2 REDLINE REVISION 9/01/04 JWA for MAR

REVISIONS					
A UPGRADE EXISTING FLASHER TO PEDESTRIAN SIGNAL SHA NO.: AT2885185				01-05-04	
JWA	WM	MAR		BRK	TH 1/20

TRAFFIC ENGINEERING DESIGN DIVISION
MD 650 (NEW HAMPSHIRE AVE) AND QUAINT ACRES DR / HEARTFIELDS DR

WHITE OAK, MARYLAND

DRAWN BY: JW ALLEN JR.	F.A.P. NO. N/A	TS NO. 4086A	SHEET NO.
CHECKED BY: S RENZI	S.H.A. NO. XX1005885		
SCALE: 1"= 20'	COUNTY: MONTGOMERY	T.I.M.S. NO. F938	1 OF 3
DATE: 4-01	LOG MILE: 15065005.40

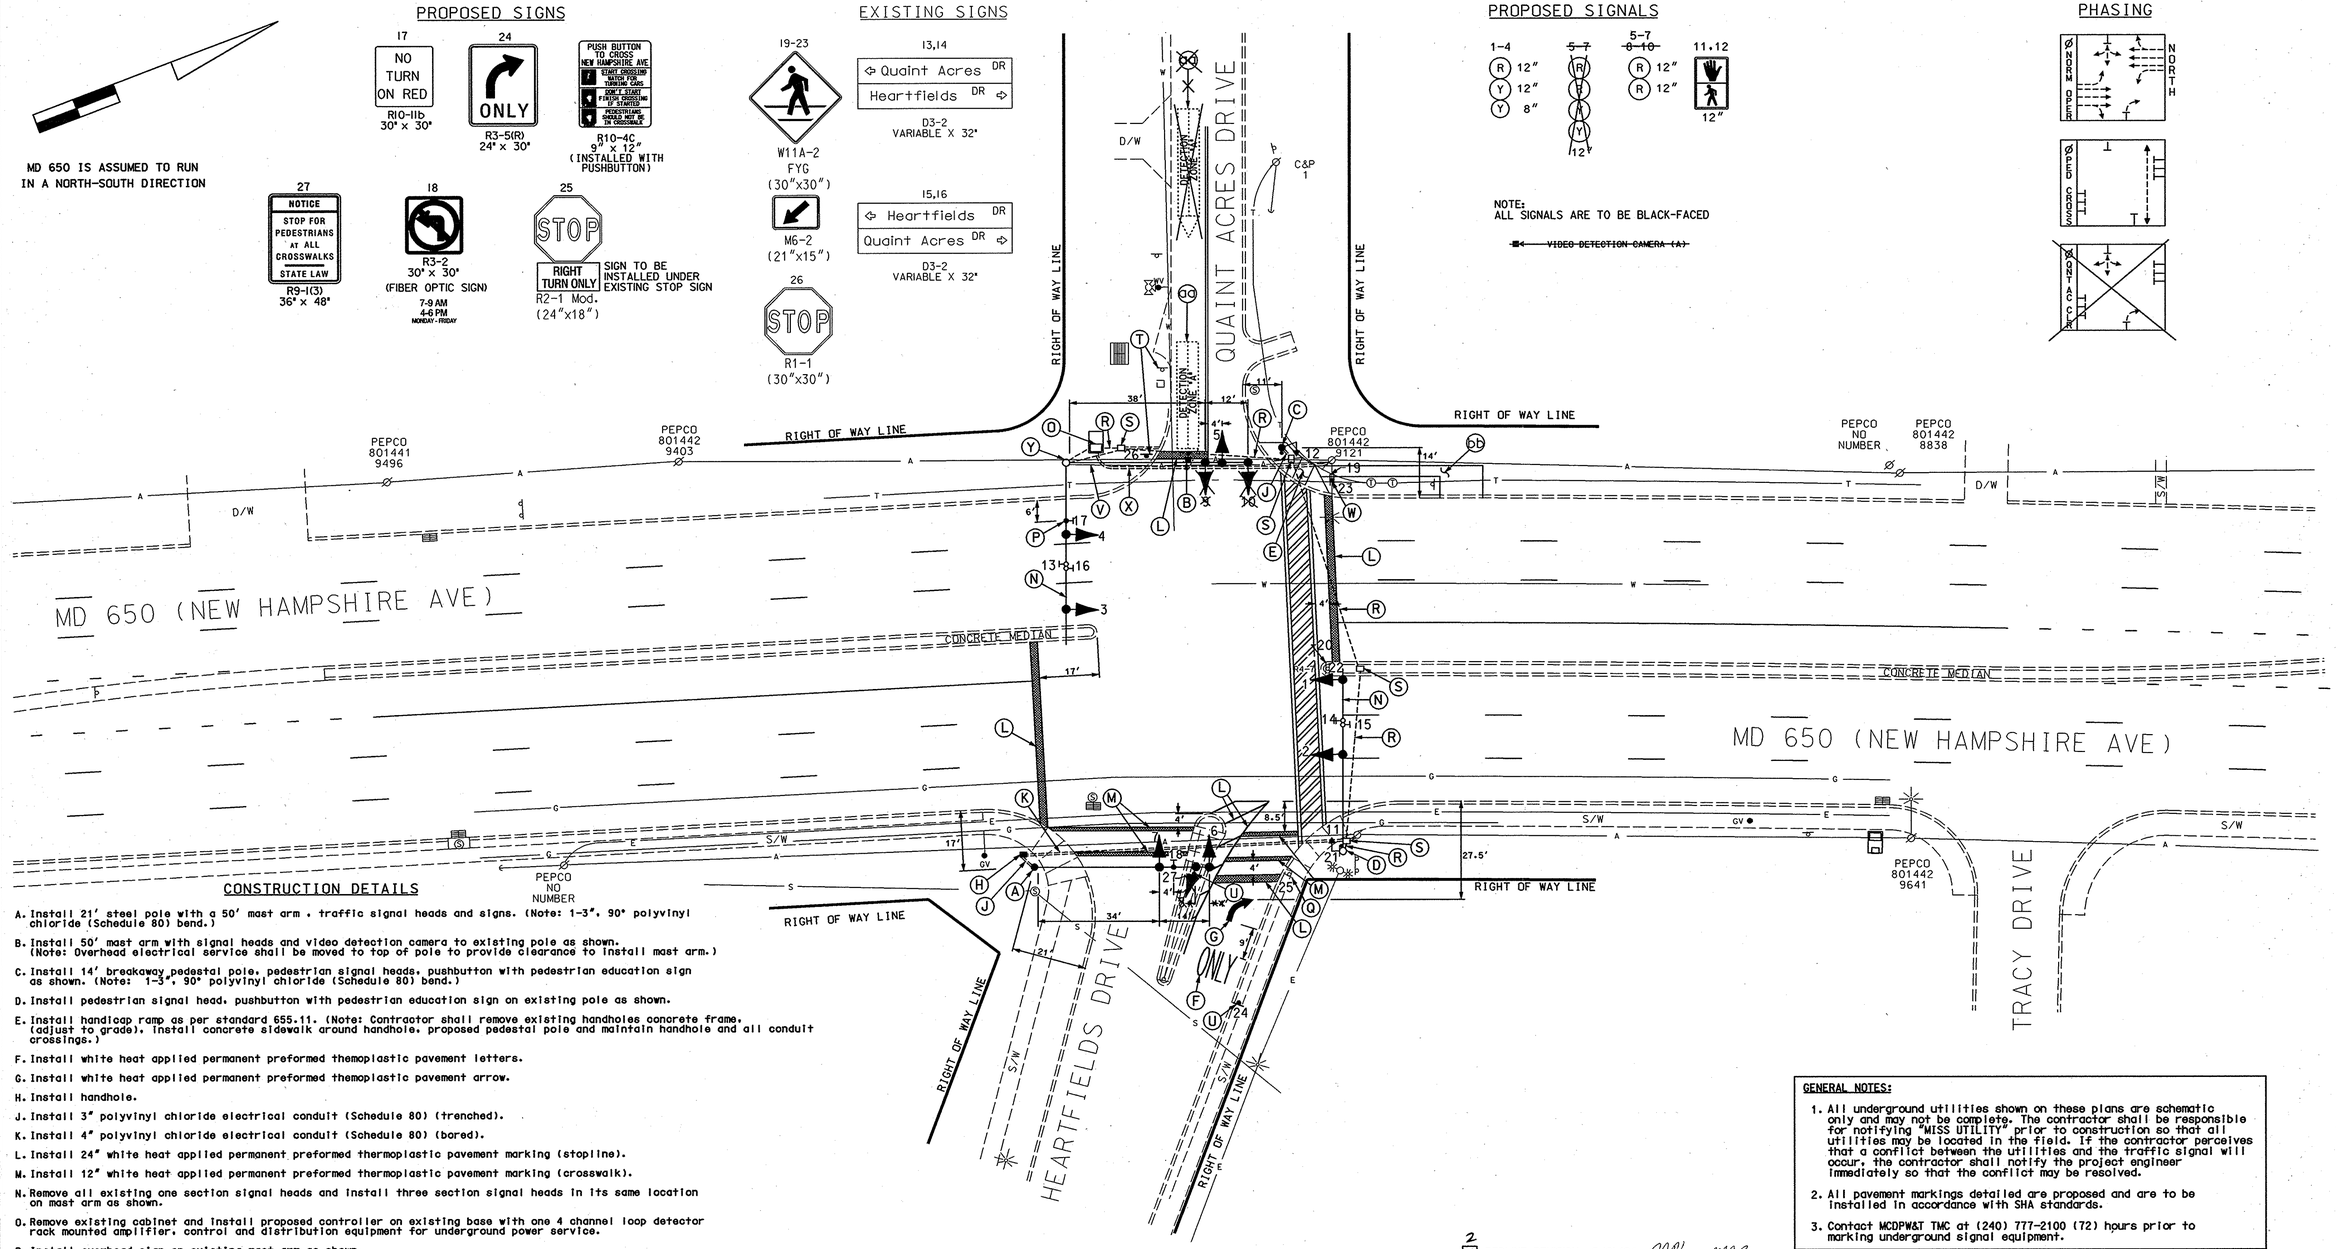
~~5-7~~: R, Y, A, Y 12"

5-7 ~~8-10~~: R 12", R 12"

~~VIDEO DETECTION CAMERA (A)~~

2 bb. Install 8'x12' bus pad and sidewalk as shown.
